From: BRYAN Martin (EXT) [Martin.Bryan.ext@areva.com]
Sent: Wednesday, March 03, 2010 10:01 AM
To: Tesfaye, Getachew
Cc: DELANO Karen V (AREVA NP INC); BENNETT Kathy A (OFR) (AREVA NP INC); ROMINE Judy (AREVA NP INC); GUCWA Len T (EXT)
Subject: Response to U.S. EPR Design Certification Application RAI No. 323, FSAR Ch 6, Supplement 1
Attachments: RAI 323 Supplement 1 Response US EPR DC.pdf

Request for Additional Information No. 323, Supplement 1

U.S. EPR Standard Design Certification

SRP Section: 06.02.05 - Combustible Gas Control in Containment

Figure 6.2.5-9—Concentration of Hydrogen in the Containment

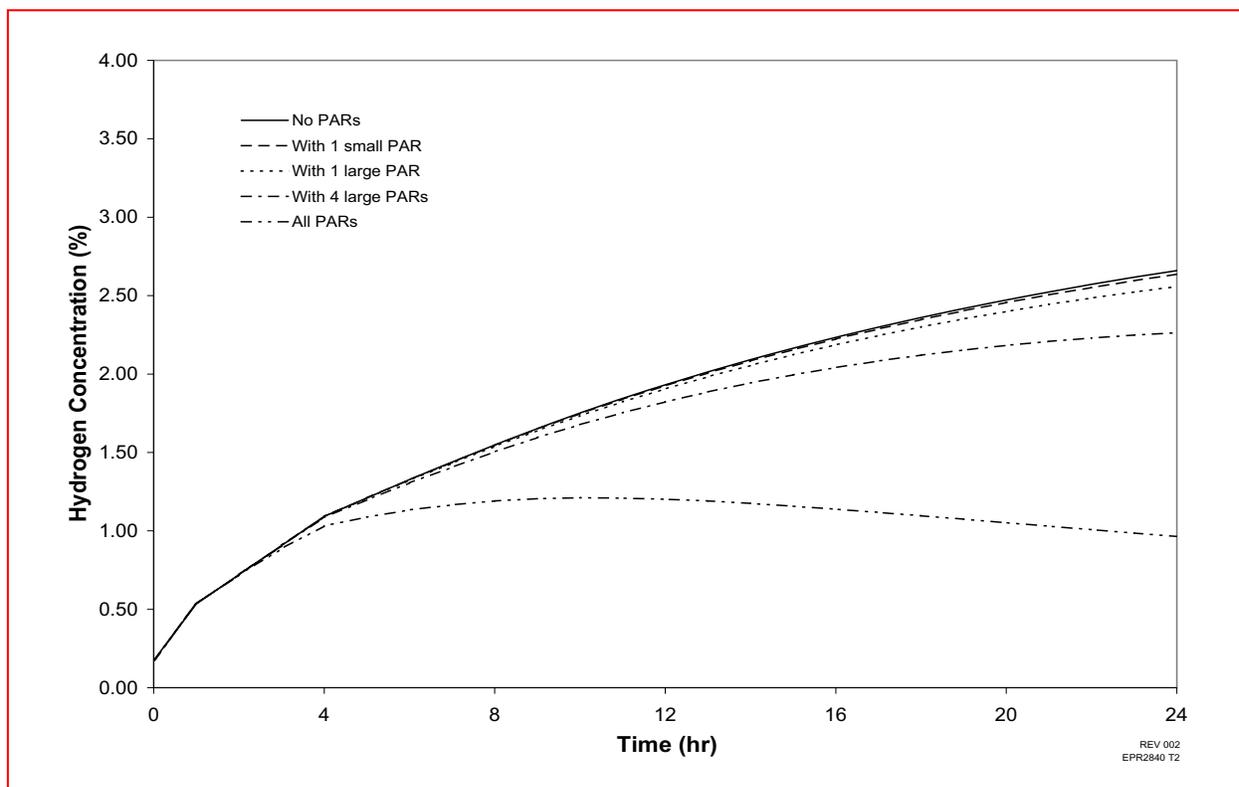
This question is a follow-up to an October 7 and 8, 2009 audit on documentation relevant to passive autocatalytic recombiners (PARs). Confirm that the PARs described in FSAR Table 6.2.5-1 are 41 large PARs with a recombination rate of 11.8 lbm/hr, and 6 small PARs, with a recombination rate of 2.6 lbm/hr. Confirm that the large and small PARs identified on FSAR Figure 6.2.5-9 represent the recombiner rates above. In FSAR Tier 1, Table 2.3.1-1, CGCS Equipment Design, the PAR individual equipment numbers and locations are provided. Confirm that the 47 PARs are identified by the equipment numbers 30JMT10AT001-047. Indicate in Table 2.3.1-1 which are the 6 small PARs.

The U.S. EPR plant is equipped with 41 large and 6 small PARs. The hydrogen depletion rate is 11.8 lbm/hr for a large PAR and 2.6 lbm/hr for a small PAR. These depletion rates are represented in U.S. EPR FSAR Tier 2, Figure 6.2.5-9. U.S. EPR FSAR Tier 2, Figure 6.2.5-9 will be revised to indicate hydrogen concentration as a function of time for different assumed operation of large and small PARs.

U.S. EPR FSAR Tier 1, Table 2.3.1-1 and U.S. EPR FSAR Tier 2, Figure 6.2.5-9 will be revised as described in the response and indicated on the enclosed markup.
